# VAN'S AIRCRAFT, INC.

### 60 amp Alternator Wiring Change!

## 60 AMP ALTERNATOR ONLY

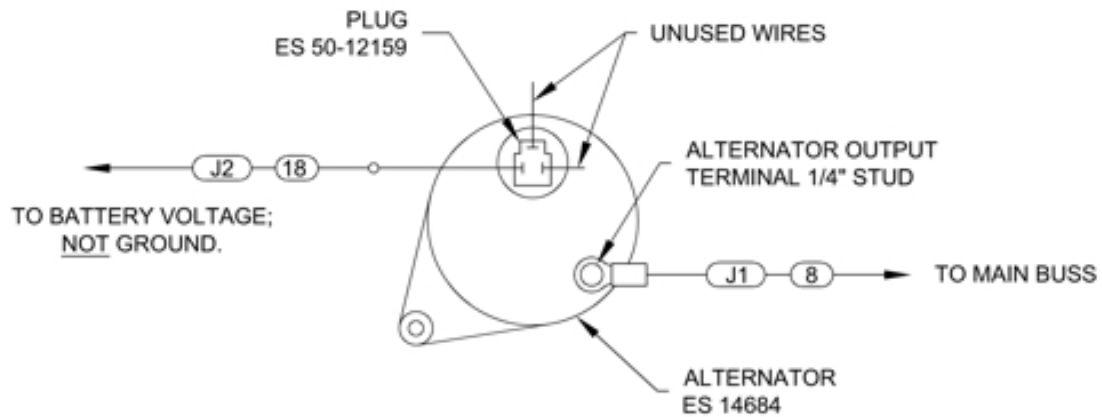
There is a three terminal plug on the back of the alternator. When viewed from the back with the two parallel terminals down, only the lower left terminal should be used. This will normally correlate to the green wire on the plug. The other two terminals (red and blue wires) are not to be used. Please see the diagram on page 2.

If your alternator is currently wired to the old configuration, all you need to do is remove the connection for the red wire. Older alternators will also function correctly with only the green wire connected.
